TECHNICAL ADVISORY COMMITTEE REPORT

FILE NUMBER: 23-DP-07

SUBJECT: Preliminary Site Plan and Design review for 40 Residential Units 2306 Fillmore Street.

(03) FRONT APPROACH SCALE: N.T.S

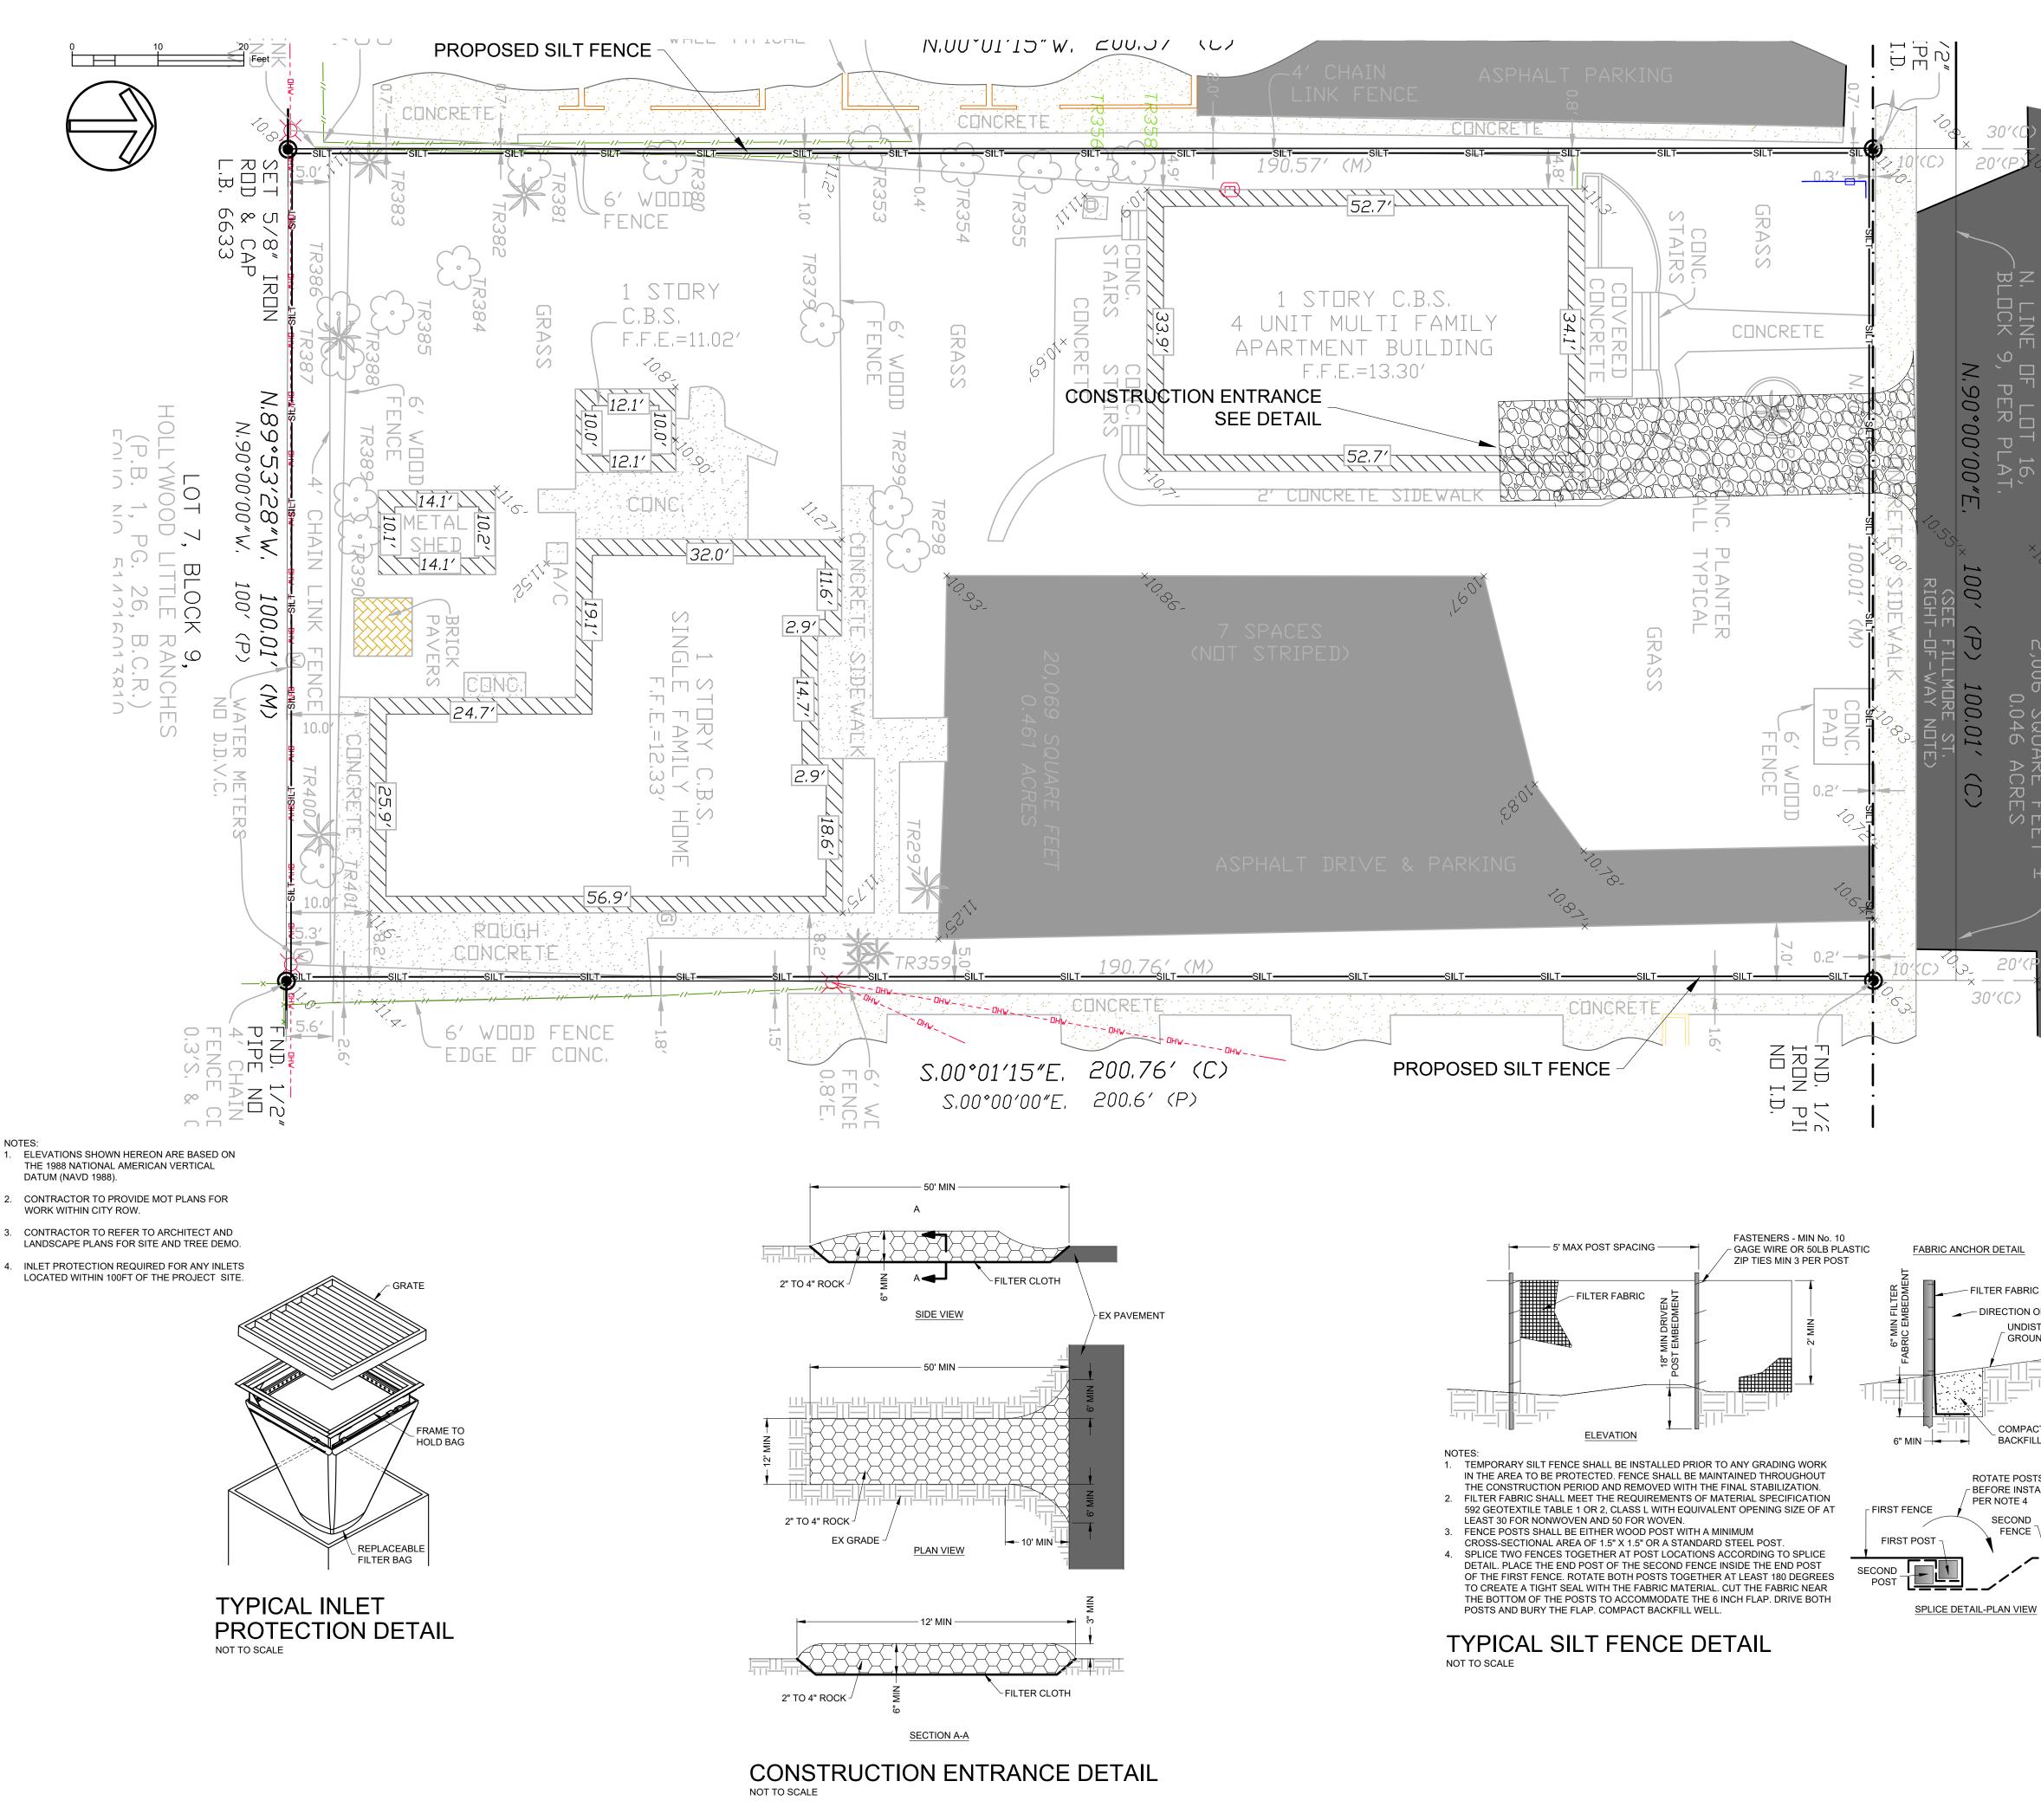
13. Sheet A-101, a perimeter wall or fence is being shown on plan at the property lines. Please label and indicate height and material of wall/fence. Provide details such a cross-section to ensure wall/fence and its footer does not encroach to adjacent properties.

Response: What is being shown is a 6' fence. A-101 is showing this detail noting the footer does not encroach adjacent properties. See detail #06 on A-101.

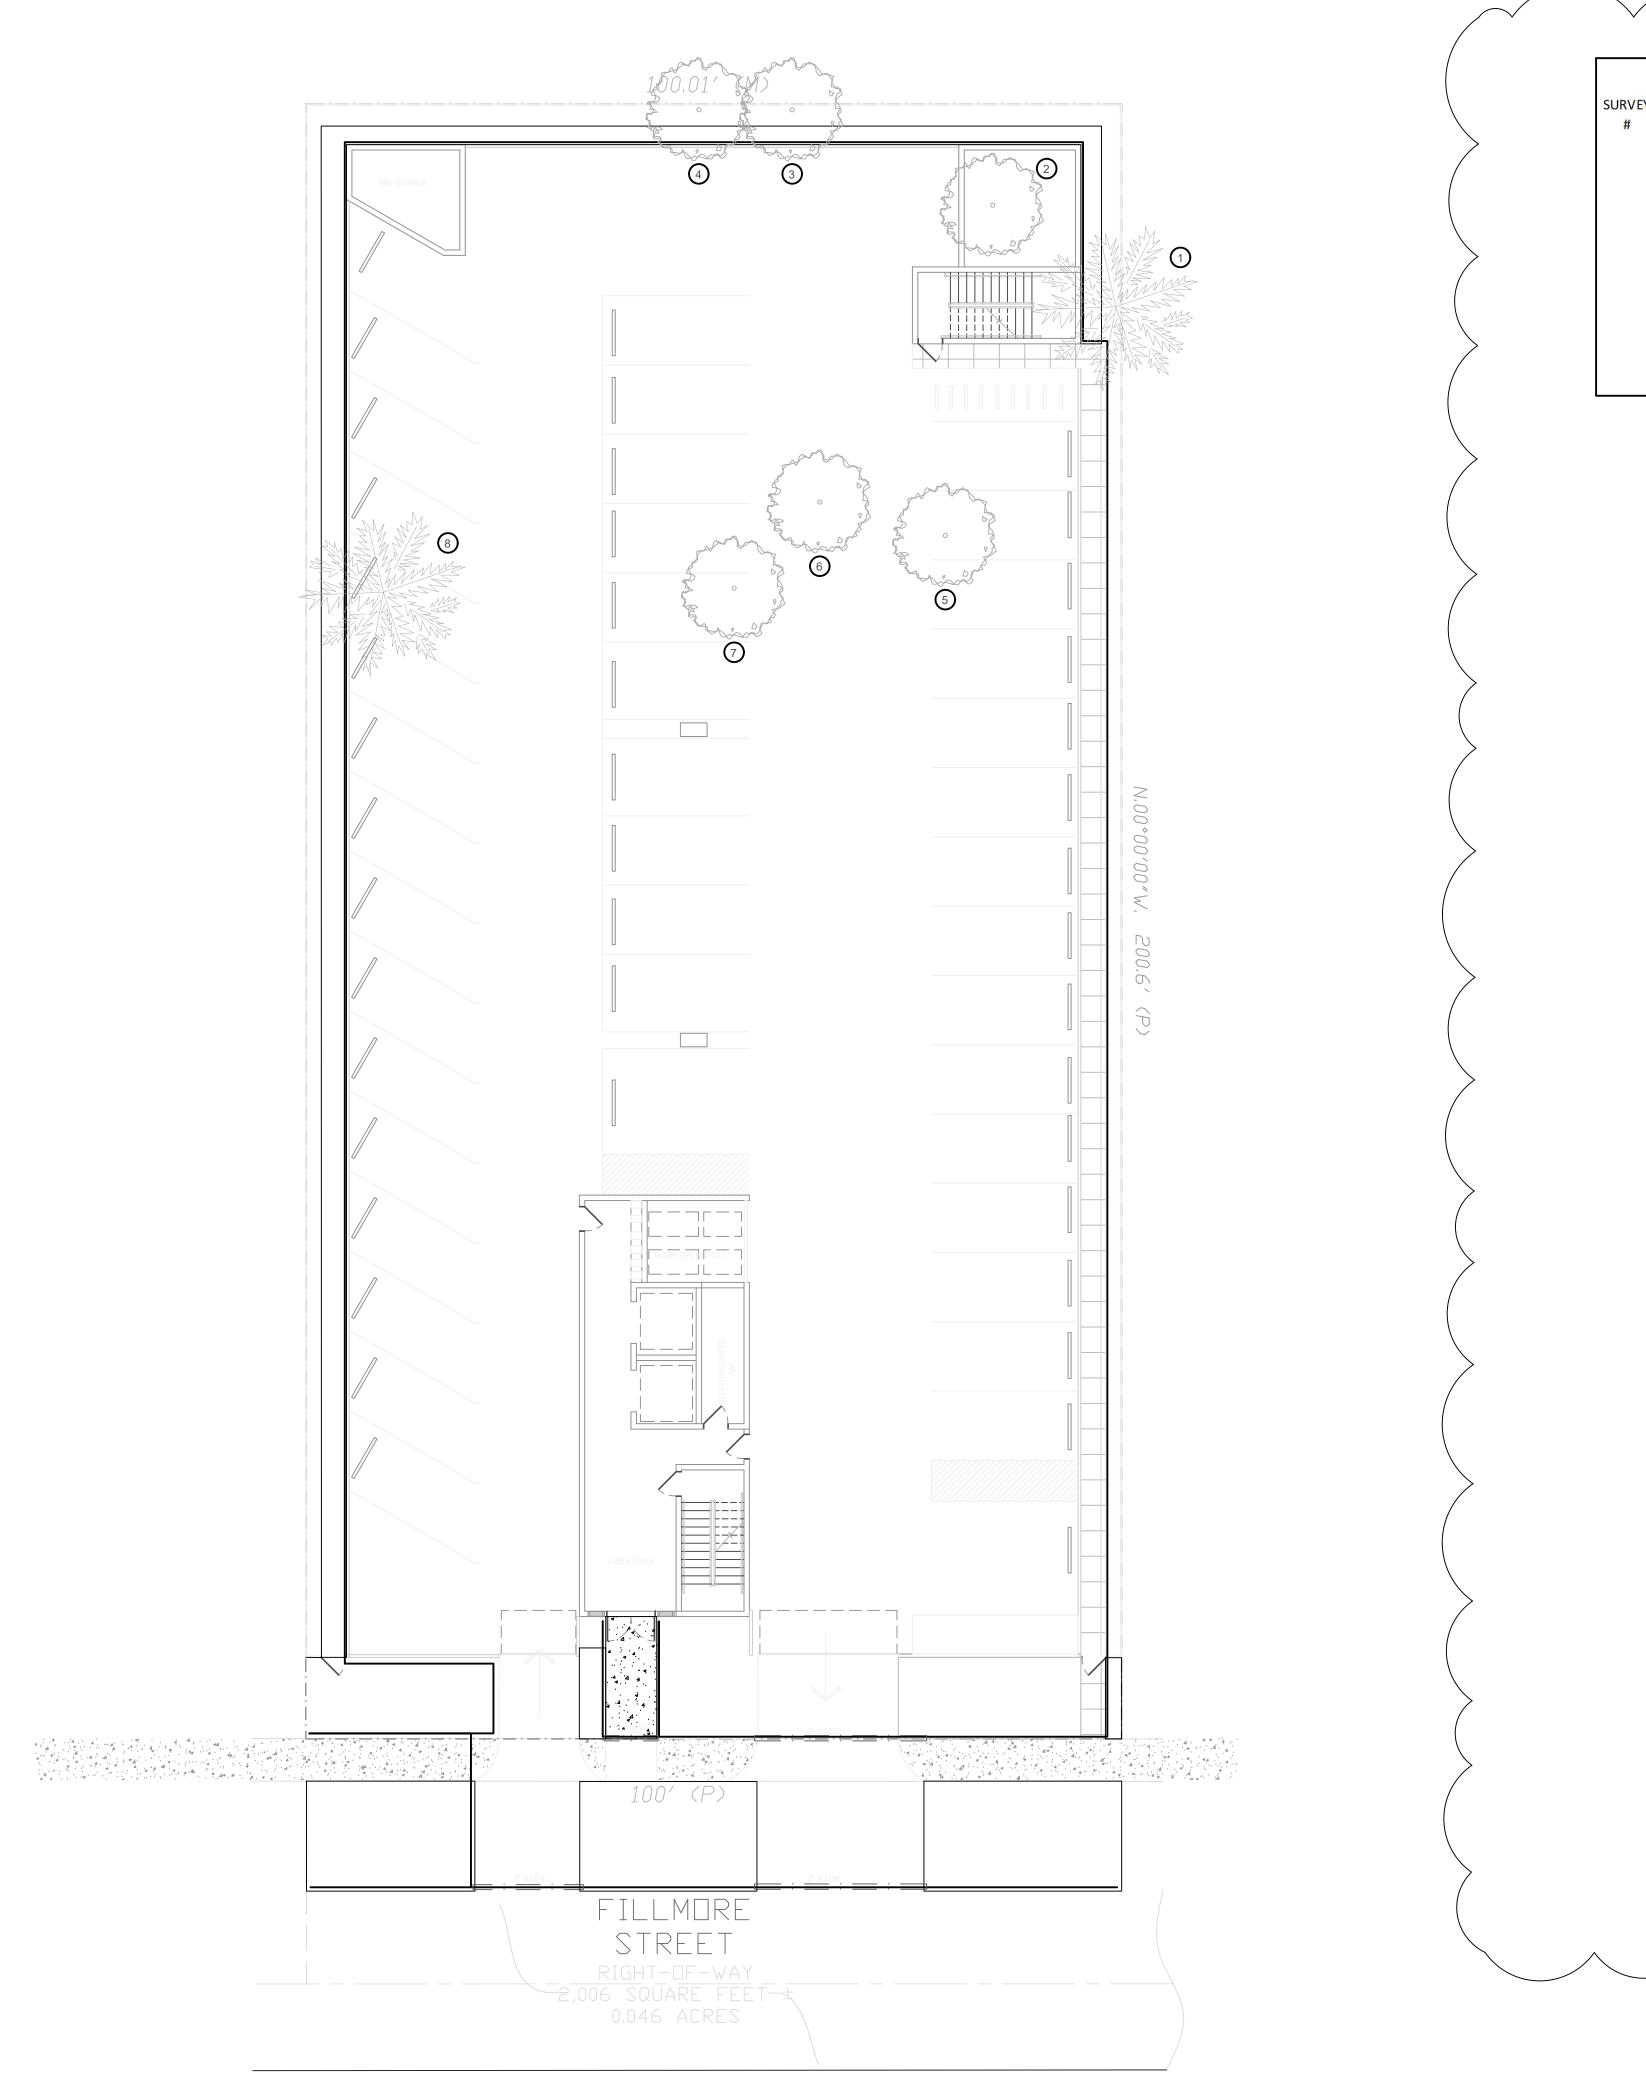
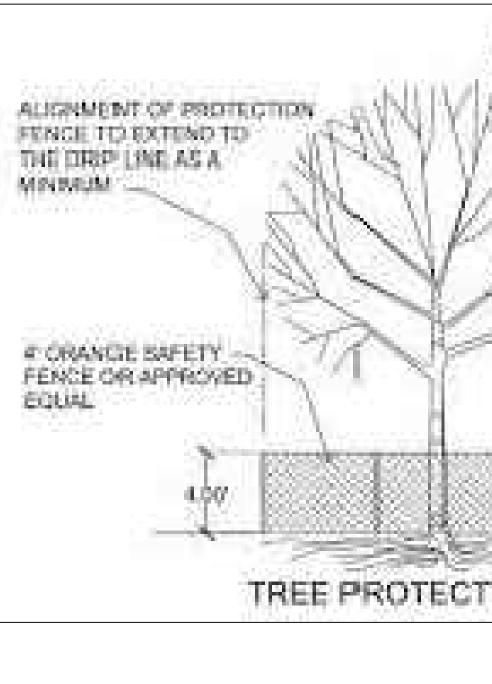
- 1. Tree survey shows 24 trees/palms on site. Landscape plan shows 8 total. **Response: Trees shown by arborist are the only trees currently on site.**
- Revise tree disposition, Norfolk island pine is a nuisance tree and exempted from mitigation.
 Response: Norfolk Island Pine has been removed from mitigation. See TD-1 with revision cloud.

- Show city approved protection detail with orange mesh.
 Response: Orange mesh tree protection has been added. See TD-1 with revision cloud.
- 4. North arrow points to wrong direction on plans. Response: North arrow is correct. See plans with revision cloud.
